**Review of the Final Report**  
**that was written by**  
**J.-L. Françon, L. Bloncourt, D. Kügler**

Dated 18 April 2017

Case Number C/09/434236/ HA ZA 13-17, and  
case number C/09/441930 / HA ZA 13-476

by  
**Experts of Claimants**

Lateral flight profile based on radar data (Figure 1 out of the Final report page 123). Added are auxiliary lines showing ATC radar direction, and legends of the original (magenta) and corrected (cyan) radar tracks.

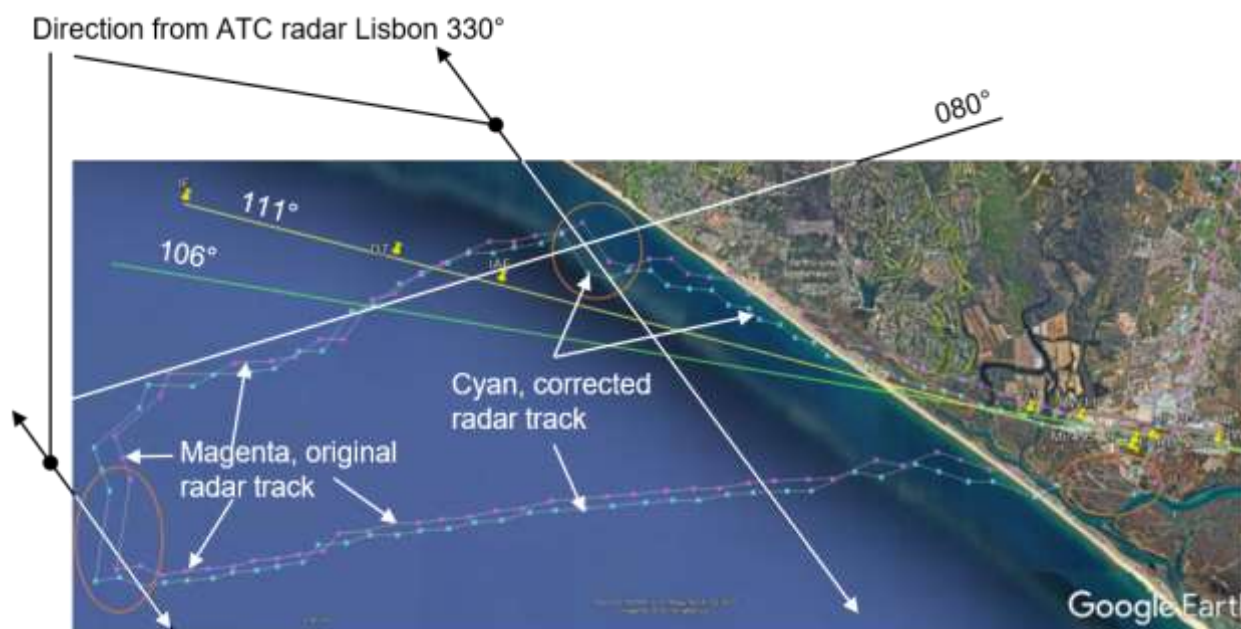
Because we know that the ATC radar is situated NNW of Faro, and nearly perpendicular to both the outbound and the inbound track during the VOR approach to Faro airport as shown with auxiliary lines in the figure below, the "error of the range measurement" indeed stays the same, not "stays more or less the same". If both the magenta and cyan tracks are from the same radar, they should however, be on top of each other. Since this

errors are near zero, the distance of the airplane track data points to the ATC radar should be very accurate. Yet, the experts emphasize "*In figure 1, the areas with orange circles mark areas with large lateral deviations within the radar track (orange circles). These effects cannot be fully explained at this point*". Experts of claimants can explain: the line connecting the data points within these orange circles point in the approximate NNW direction of the ATC radar near Lisbon; for these points the range errors would apply, not the lateral deviations (if seen from the airport). As explained, range data is very accurate, hence the data plots might not be as accurate as experts think they are. The cause of the data jumps could be errors in the acquired data; these data points should not be used. The radar horizon may play a role here as well.

- 3.4.6. The "*Lateral flight profile*" (should of course just be called the flight track) in the title of Figure 1 on page 123 of the Final Report (is the figure above) shows that, from the orange circle in the bottom left, the airplane flew at a heading of approximately 080° for 20 consecutive radar position points. One data point per 5 sec. (as the experts specified) results in 100 seconds of flight at heading  $\approx$  080°. The DFDR data dump provided by the NTSB however, shows only 34 seconds of flight at 080° heading. Experts of claimants rather believe the objective DFDR data to be correct and the analysis by the experts incorrect.

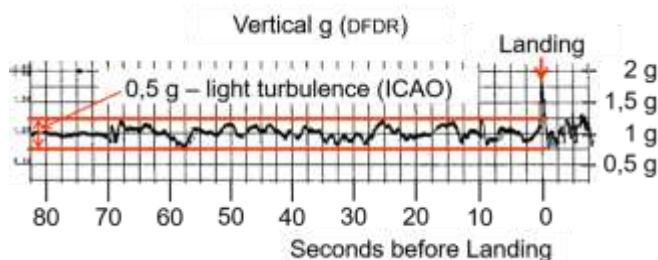
5.1.4.1. "Calculated wind must be considered". Calculated wind? If experts had verified and calculated the wind, then they would have concluded that the constant heading of 125° during the approach could only have been caused by a constant crosswind component of 20 kt, such as caused by the wind that the captain read from his navigation

display at 10 sec. before touchdown (190°/ 20 kt, see also § 5.1.7.4 below). Were there "induced accelerations"? Experts "refer to passengers' or crew members' statements", but objective DFDR data only show normal (vertical) accelerations less than

0.5 g, as result of light atmospheric turbulence, during the last 70 seconds of flight, as the DFDR data in the figure above proves.

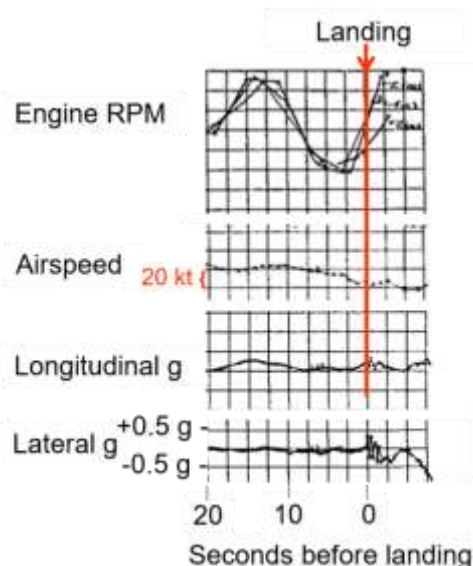
5.1.4.2. There were no (induced) lateral accelerations before landing as the DFDR

data proves (adjacent figure). The small recorded lateral accelerations were caused by rudder inputs by the copilot. The only recorded longitudinal accelerations coincide with engine RPM changes that occurred because the pilot pushed and pulled the elevator controls to which the autothrottle respond immediately (refer to § 3.8 above), and in the last seconds, the longitudinal acceleration increased due to the application of thrust for the go-around. The airspeed decreased because the copilot kept the throttles closed from 15 seconds before landing, until the captain increased them for the go-around at 4 seconds before landing. There were no other accelerations, hence the winds did not "induce accelerations and turbulences", as

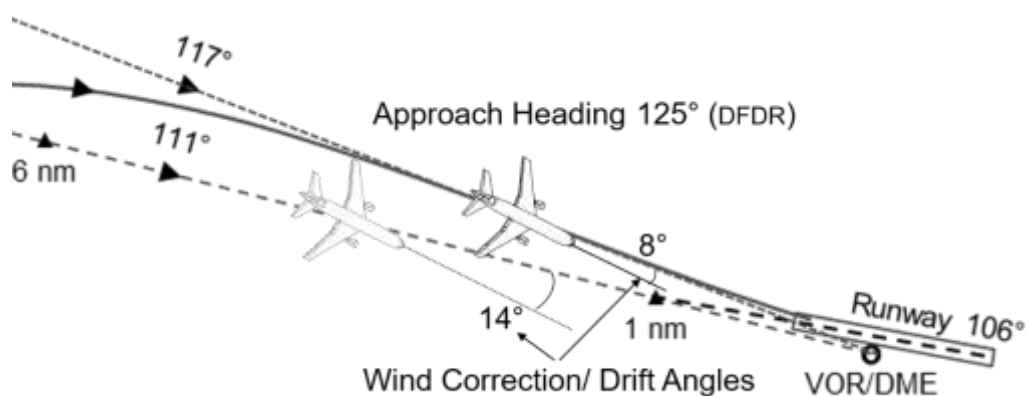
5.1.7.1. The DFDR data (figure below) show that the approach heading of 125° did not change during the last 80 s of flight, with the exception of the small heading changes (yawing) due to (inappropriate) rudder inputs by the copilot between 40 and 13 seconds before landing and during the last 12 seconds of flight. This also means that the wind was constant, otherwise the heading would have been increased to larger than 125°.

5.1.7.2. On FR page 150, Experts wrote: *"The rudder movements are quite important but it is not possible to qualify them as abnormal according the weather conditions (thunderstorm, wind rotation and rain)"*. Abnormal is the inappropriate application of

rudder already from 40 seconds before touchdown, even before reaching the 1 nm point in front of the runway threshold, as shown in the figure above. Experts will not have reviewed AIDS data, RoA Annex 9 chart 6. An expert will be able to "qualify" rudder movements, because these data are in the DFDR and AIDS reports. See also ref. D. The rudder movements during the last 12 seconds are indeed not abnormal because of the requirement to align the airplane with the runway before landing.

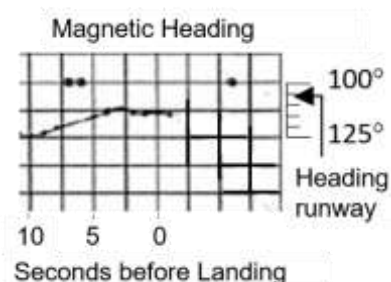
5.1.10. **The correct answer to the court is:** There were no sudden and unexpected wind variations in direction and speed (windshear), no microbursts and no tail wind in the final stage of the approach, but indeed a too high crosswind component of 20 kt during the approach and landing, which exceeded the aircraft limits (5 kt for a flooded runway, 15 kt for a wet runway), as was listed as one of the causes of the accident in the RoA.

The pilots were aware of the strong wind because of the required large 125° approach heading, the ATC provided wind of 150°/ 15 – 20 kt and the on-board measured wind of 190°/ 20 kt but nevertheless continued the approach.

The shaded aircraft image shows the position according to the experts, the solid lined image according to experts of claimants i.a.w. DFDR and AIDS data analysis.

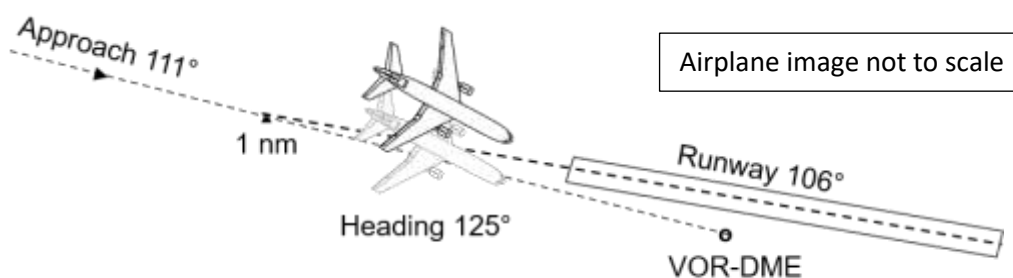
5.2.1.2. If the airplane would have been flying at the extended runway centerline (106°), with the on-board measured actual crosswind (190°/ 20 kt) that was confirmed to be correct in § 5.1.7.4 above, then the wind correction angle would have to be 8° and the heading within 1 nm from the threshold had to be 106° + 8° = 114°. With the ATC-provided wind (150°/ 20 kt), these data would be 6° and 112°, respectively.

In both of these cases, there would have been ample rudder control power to reach the 106° runway bearing with 90% rudder deflection. Even if the wind would have been 220°/ 35 kt, as was suggested, then still adequate rudder control power would have been available to line up with the runway. The 90% rudder input by the copilot however, was not adequate to align the airplane with the runway from the DFDR recorded approach heading 125°, as shown in the figure with the magnetic heading of the last 5 seconds above. Hence, the airplane was not approaching on the extended runway centerline (106°) but on the 117° radial as analyzed in § 5.1.7.4 above and shown in the figure below. Ref. D presents the detailed analysis on this subject.
